Date: 9/13/04

To: T10 Committee (SCSI)

From: George Penokie (IBM/Tivoli)

Subject: SAS UML Corrections

Figure 15 — State machine and expander device, expander port, and expander phy classes

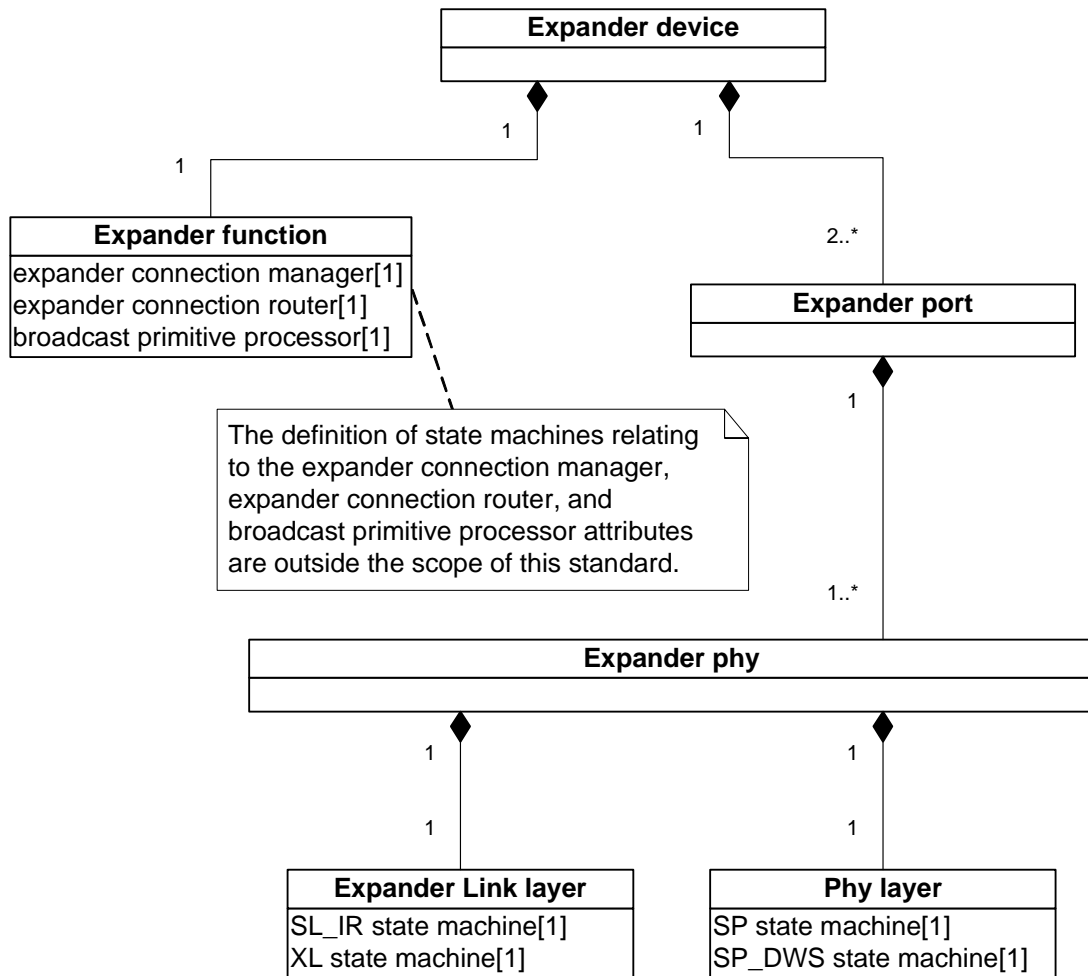
Figure 15 shows which state machines are contained within the expander device, expander port, and expander phy classes.
